### BULLETIN NO. 6

491/20167.SDW - PHASE 500:  
CENTER FOR FORENSIC PSYCHIATRY- CREATE KITCHEN  
SALINE, MICHIGAN

WTA Project No. 2021094  
NOVEMBER 05, 2025

Attachments: Sheets A2.31, A7.01

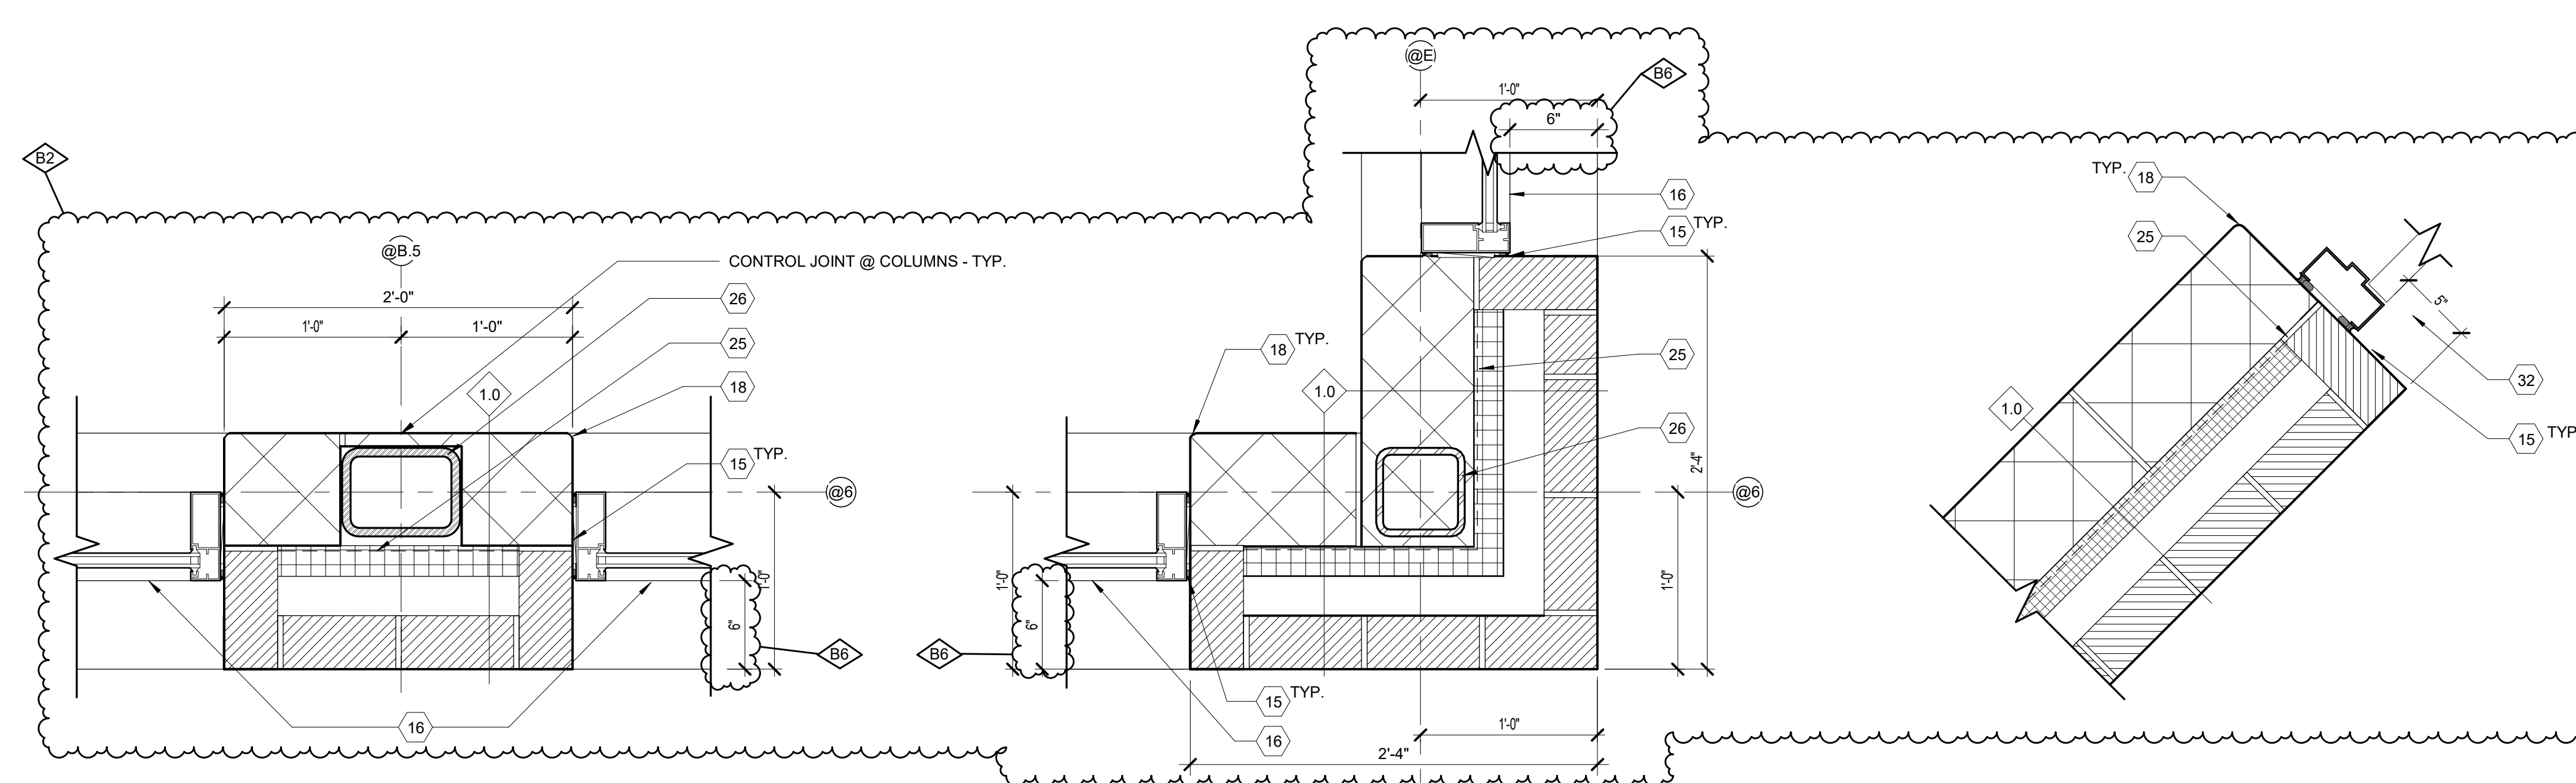
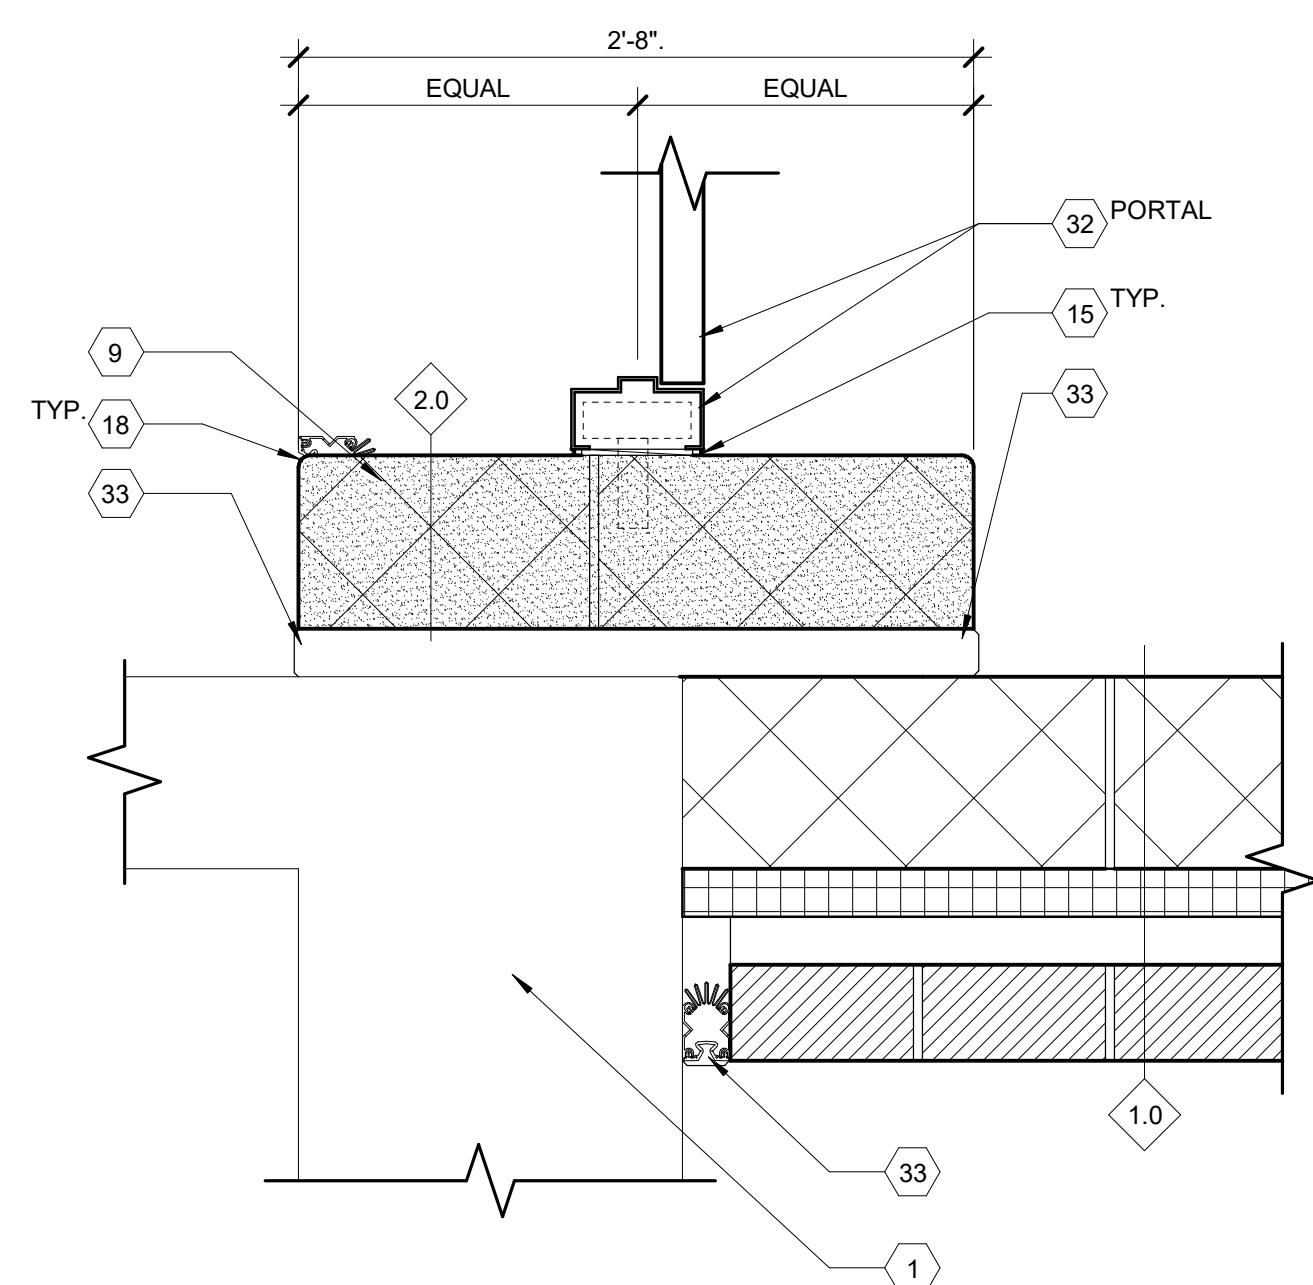
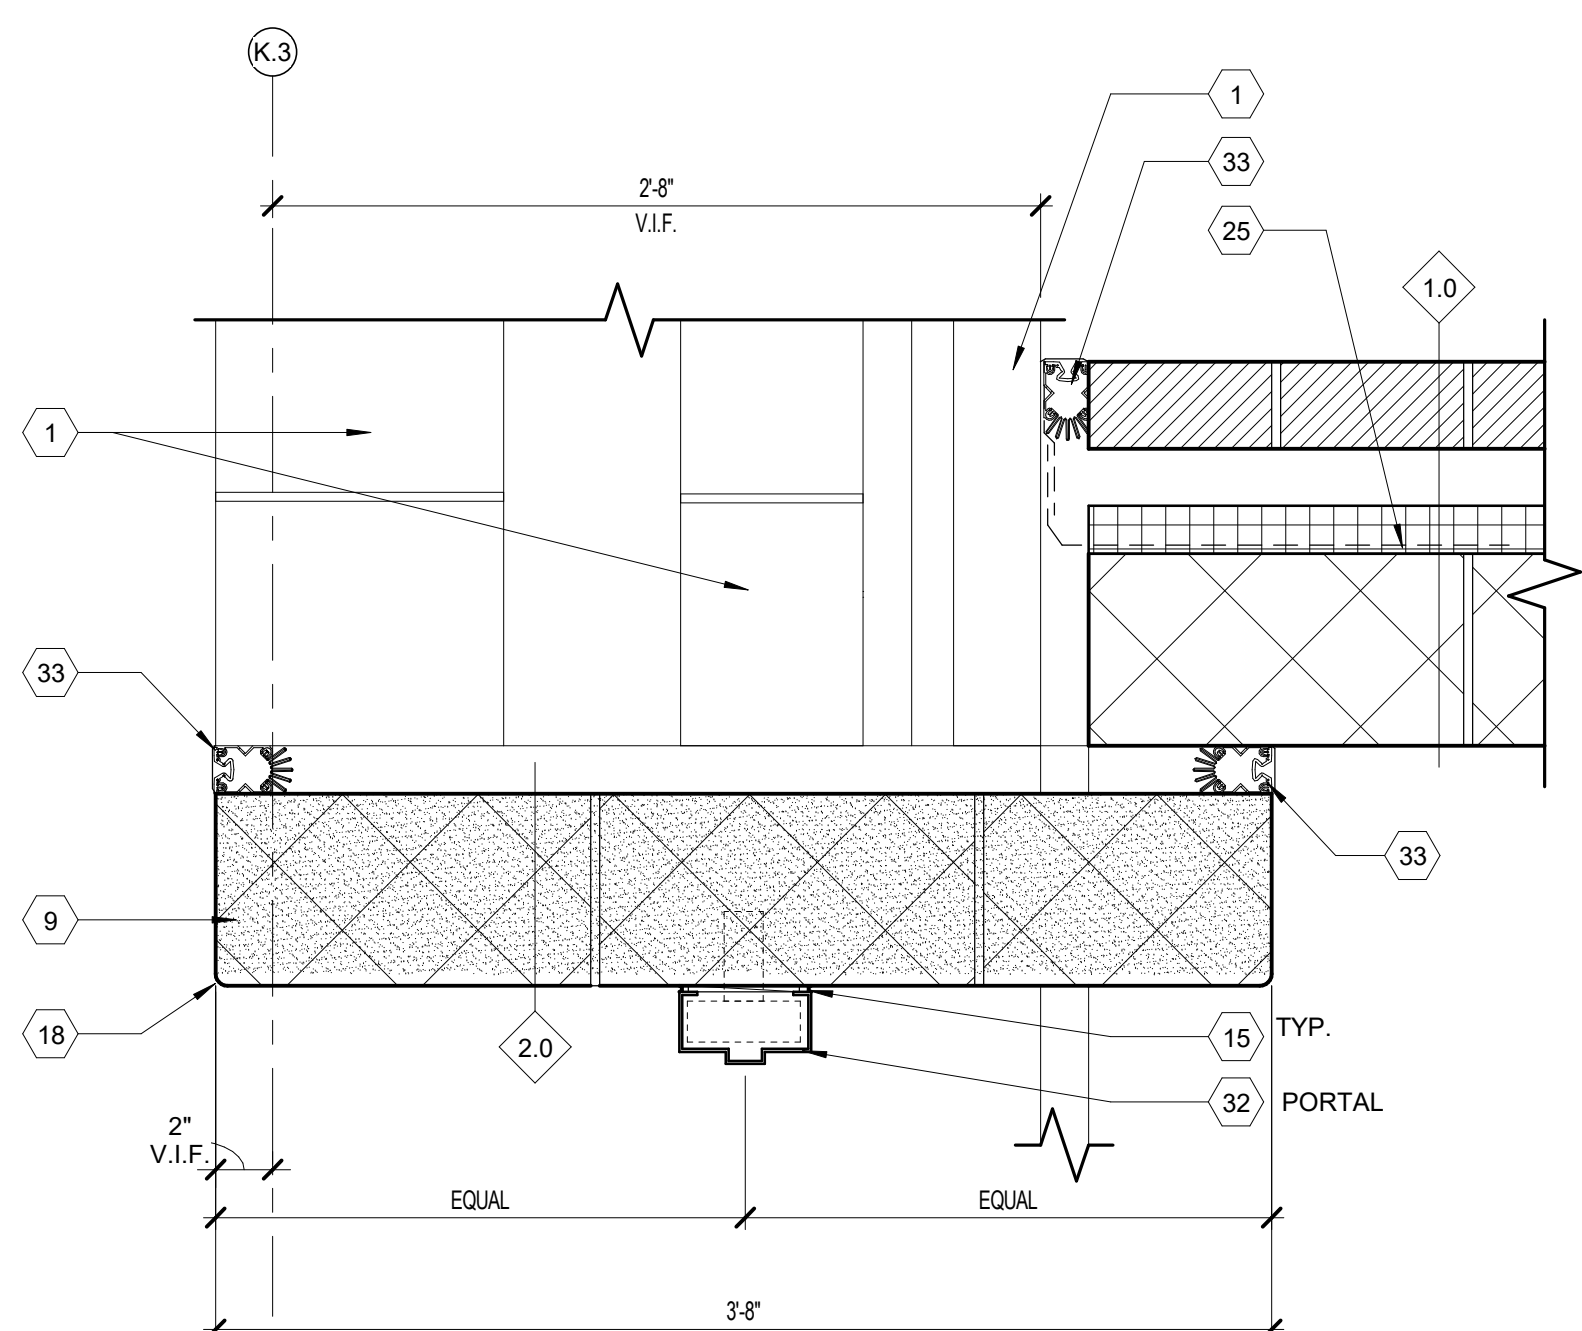
- Item A1      Reference Sheet A2.31, A7.01 **(Re-issued)**
- A. Revised windows to sit 6" from the face of the exterior wall in lieu of 3".
  - B. Added thru wall flashing, extruded aluminum flashing, and weeps under the window as indicated on attached sheets.
